Evaluation of Relay Frame Structures and Recommendations for Changes

IEEE C802.16m-08/1058

Session 57, Kobe, Japan re: **SDD Session 56 Cleanup**

SDD Session 56 Cleanup: Material in support of SDD comments on relay frame structure. For discussion and adoption by the TGM

Proposed modifications to Option 1 FS to support SCH/BCH and MBS transmissions

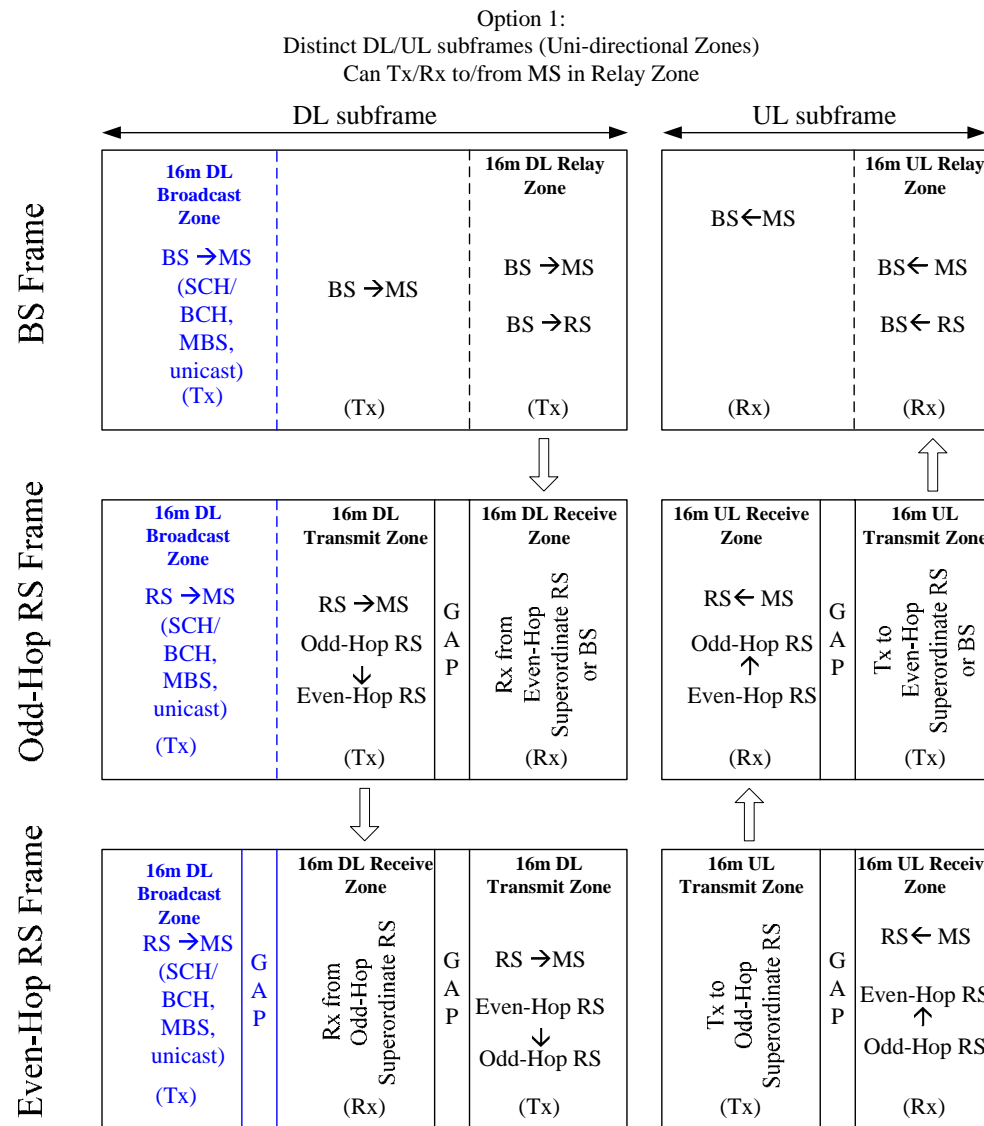
- It is not clear how SCH/BCH broadcast and MBS are supported in FS Option 1 because Even hop RSs do not transmit to the MSs at the same time as the BS and Odd hop RSs in the current option 1 FS.
- We propose that an additional zone be added to the DL portion of the Option 1 FS in order to provide a common place for SCH/BCH and MBS transmissions
 - SCH/BCH and MBS are synchronized across relay and non-relay sectors
 - An additional gap is required for even hop RSs and one possible DL/UL ratio is eliminated
 - See DL/UL ratio and Switching point analysis for details

Sector Throughput in FS Option 2 DL with Spatial Multiplexing

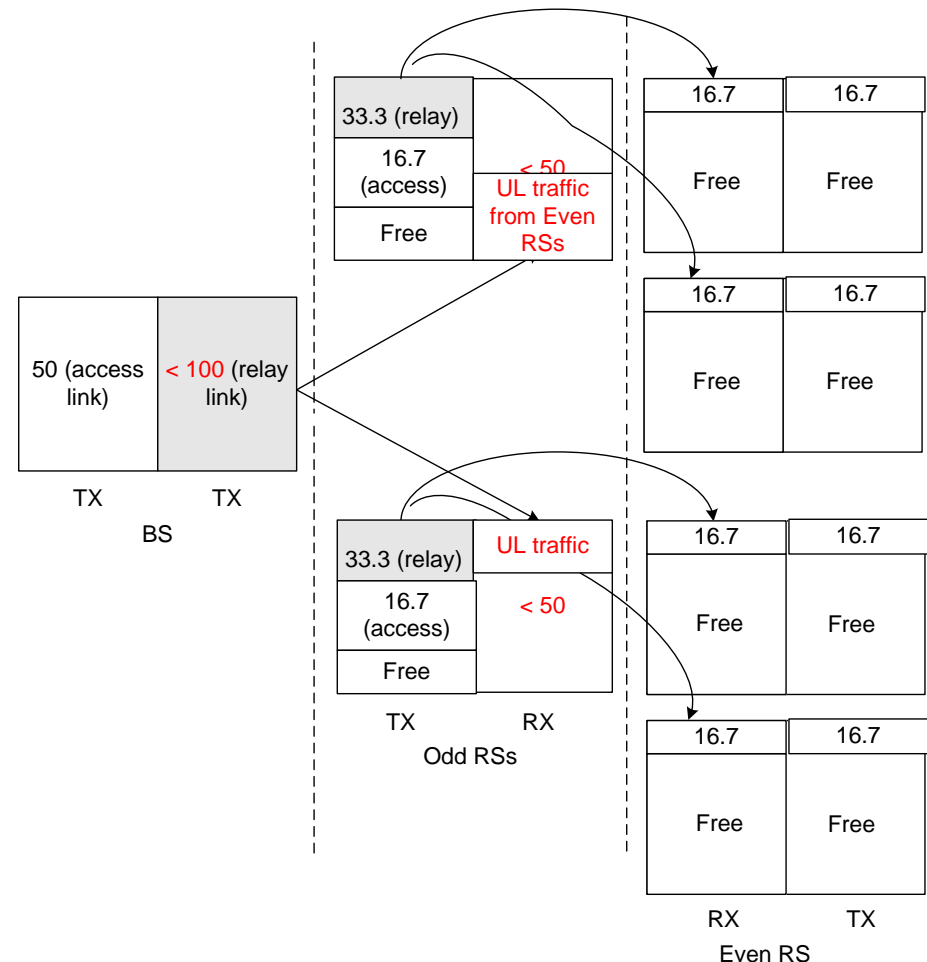
- Relay zone in Option 2 BS frame structure supports BS-RS DL and RS-RS UL
- BS cannot easily transmit to RSs during the part of the zone in which they receive UL transmissions from their subordinates
 - This either results in a decrease in maximum sector throughput
 - Or RS must implement complex SM techniques allowing BS and subordinate RS to transmit different data streams simultaneously; Variant B of symbol structure would need to be used, increasing pilot overhead

DL/UL Ratios with Option 2

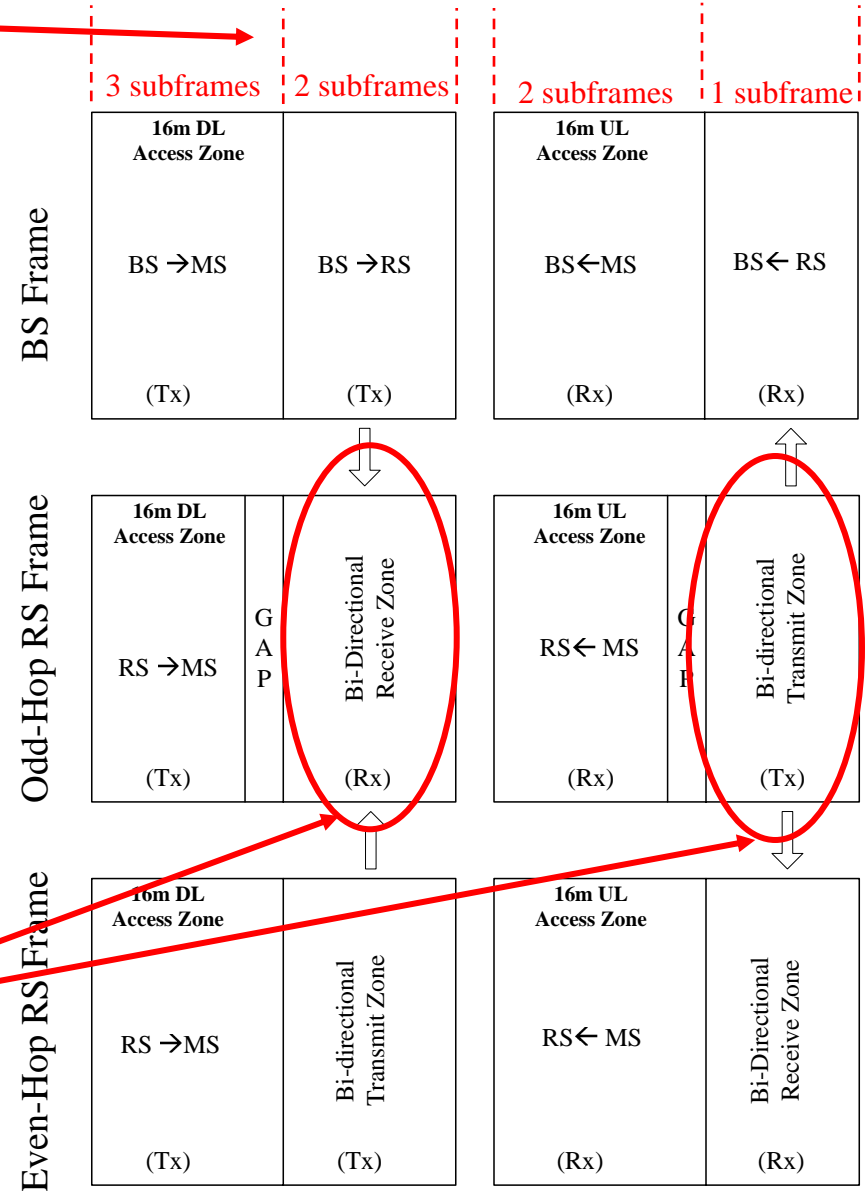
Zones must be split according to DL/UL ratio because all traffic flows through the BS, so the DL/UL ratio must exist in the BS frame

- In example on the right we assume DL/UL Ratio of 5:3
- 6:2 ratio is more problematic
- 2:6 and 3:5 ratios are also problematic, but these are not commonly used.

Odd hop RS receives 2 subframes of DL data from BS has only 1 subframe to transmit DL data to its subordinates

Adding Broadcast zone to FS Option 1

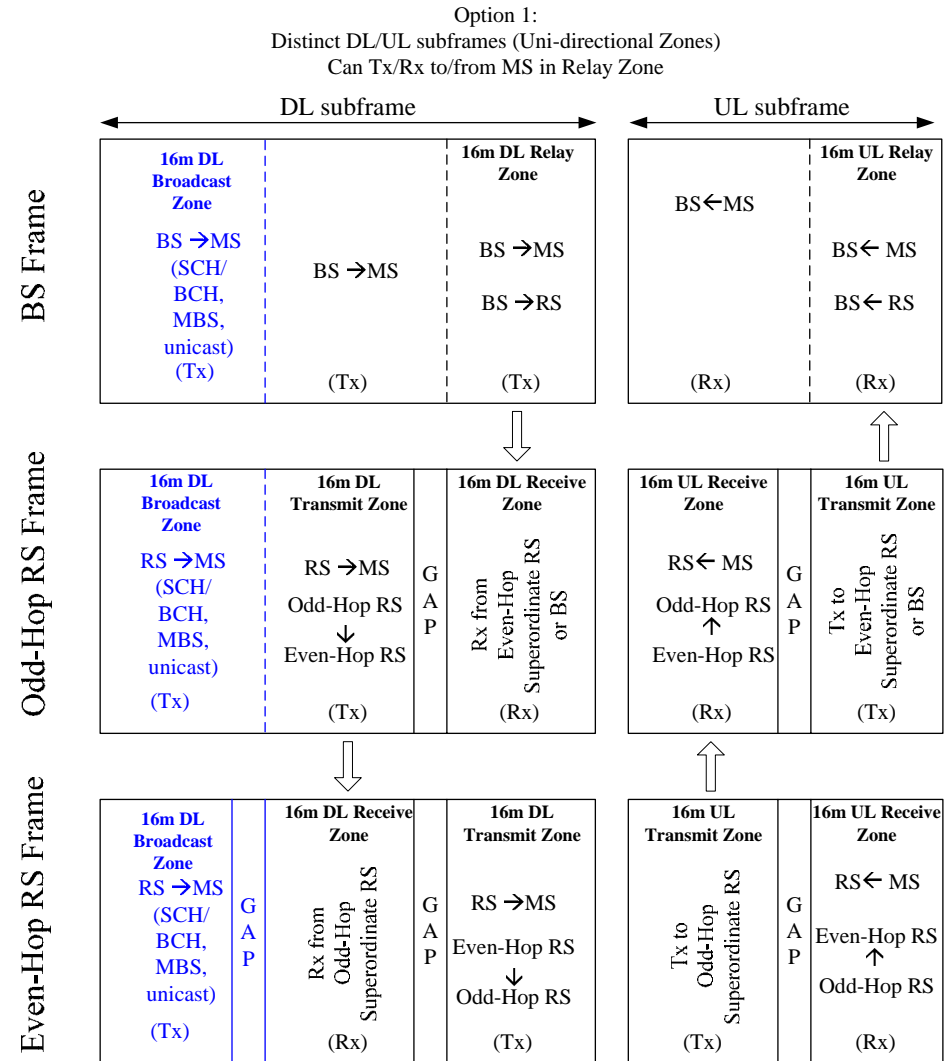
[Modify figure 23 on page 40 as indicated in the figure on the right]

- 16m DL Broadcast Zone: An integer multiple of subframes located in the 16m zone of the DL of the 16m BS frame or 16m RS frame, where a 16m BS or a 16m RS transmits the SCH and BCH. MBS transmissions and unicast transmissions to the MSs may also occur in this zone.
